REV. 1 2/22/21

119 TWIN FIELDS DR  
 FUQUAY VARINA NC  
 SCALE: 1/4" = 1'-0"

Roof build @ 119 Twin Fields Dr

Fuquay Varina NC 27526

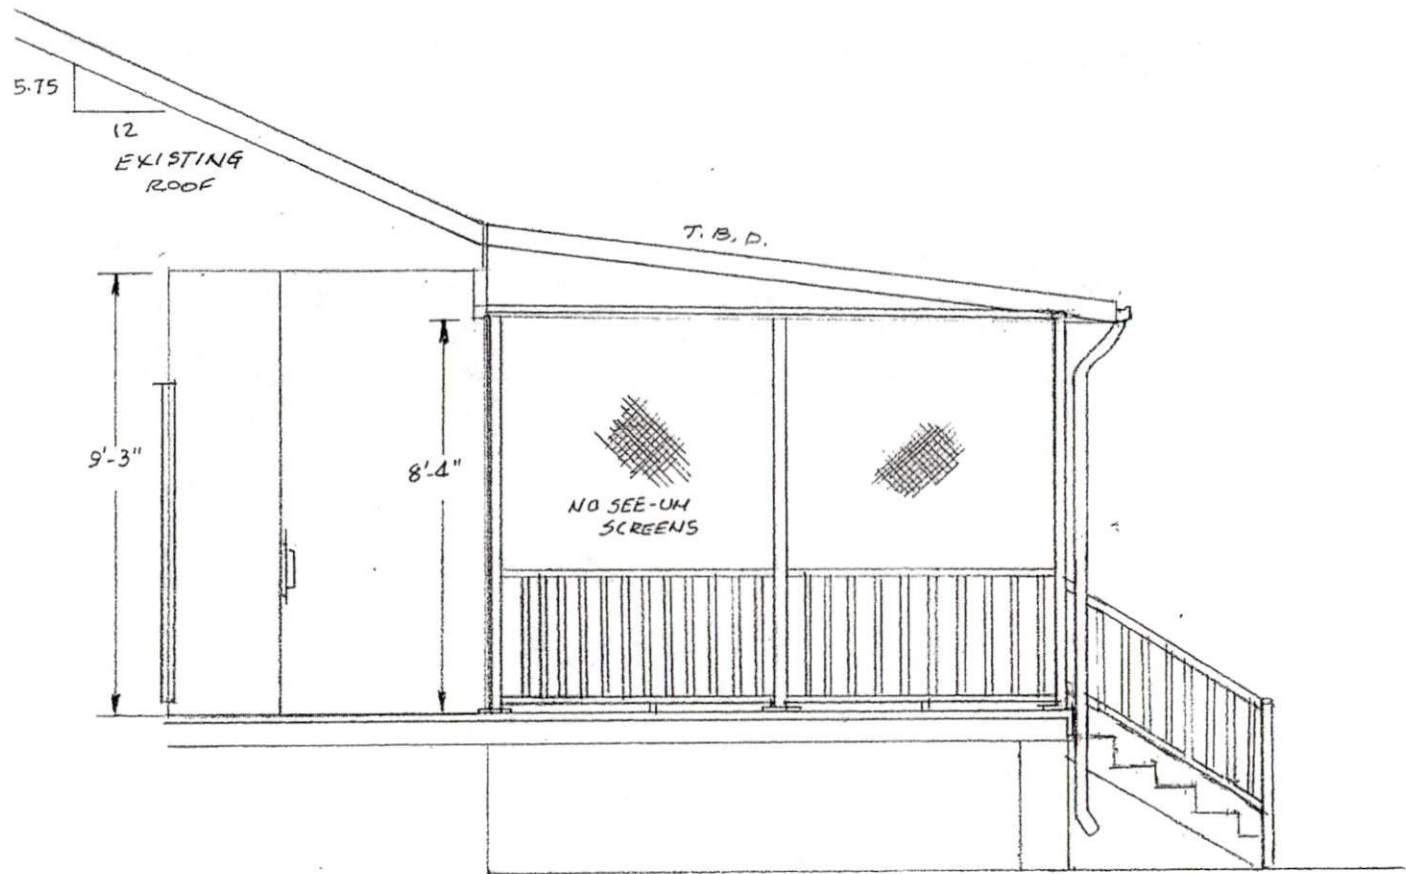
- 1. RELOCATED STAIRS
- 2. CHANGED DOOR SWING
- 3. LOCATION OF CEILING FAN OUTLET BOX
